Service Letter No. 212

Subject: Nose Wheel Shimmy Dampener, Part No. 13086-00

Models Affected: All 1953 Model PA-22's with serial numbers 22-807 to 22-1614 inclusive, 22-1616 to 22-1631 inclusive, 22-1633 to 22-1635 inclusive, 22-1638, 22-1642, 22-1646 to 22-1648 inclusive, 22-1651, 22-1653, 22-1655, 22-1656, 22-1658 to 22-1661 inclusive, 22-1666, 23-1667, 22-1672, 22-1678, 22-1680, 22-1682 and 22-1683.

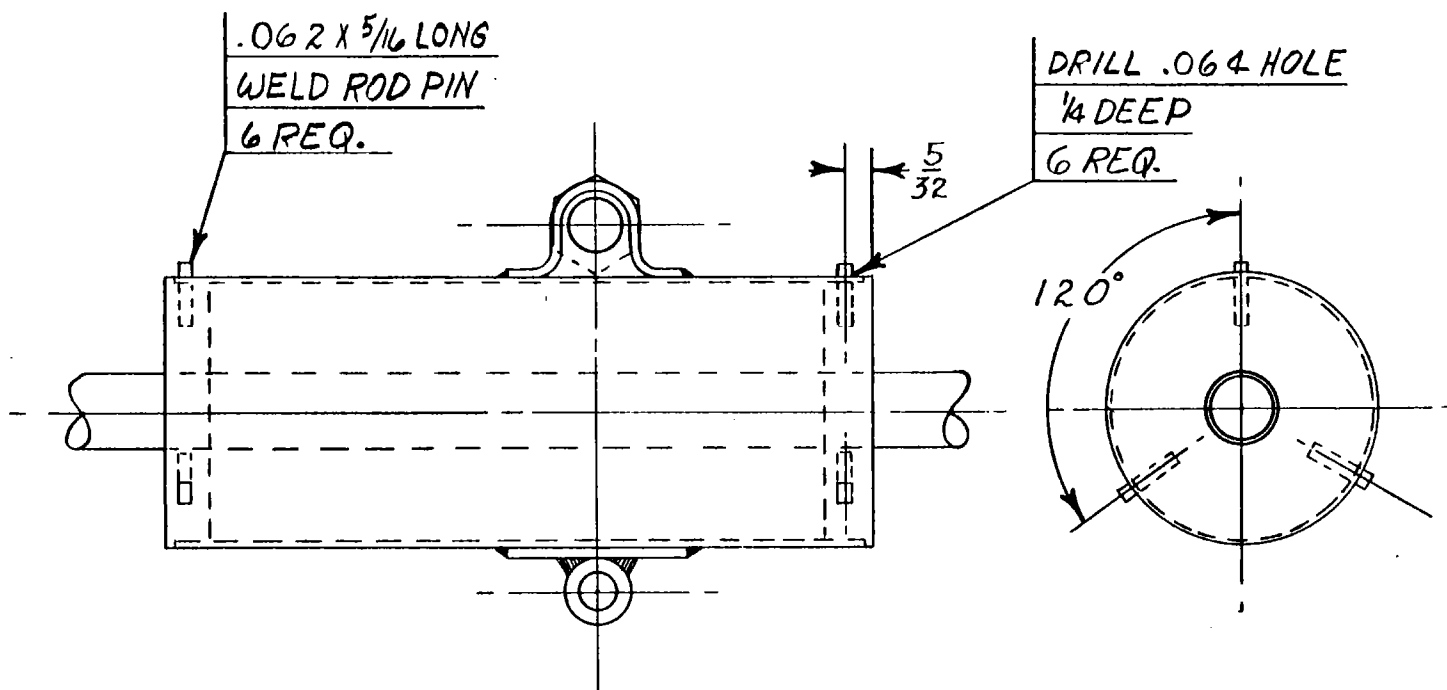
During the past few months we have received from the field a number of shimmy dampeners, part number 13086-00, on which a separation has occurred between the assembly body and the end plate. This separation was due to solder breaking loose and the internal fluid pressure plus the friction of the plunger forcing the end plate outward.

There is a possibility that a binding action will result and it is therefore recommended that regular inspections be conducted at this point to be on guard against possible failure.

All production airplanes have been modified in accordance with the sketch shown on the reverse side of this Letter and it is felt that this modification can be satisfactorily executed in the field as a service-fix. Upon inspection if the shimmy dampener shows signs of separation, it will be exchanged free-of-charge at the nearest Piper Distributor or Dealer.

NOTE:

DRIVE PIN INTO EACH HOLE AND SOLDER END, COVERING
PIN WITH SOLDER.
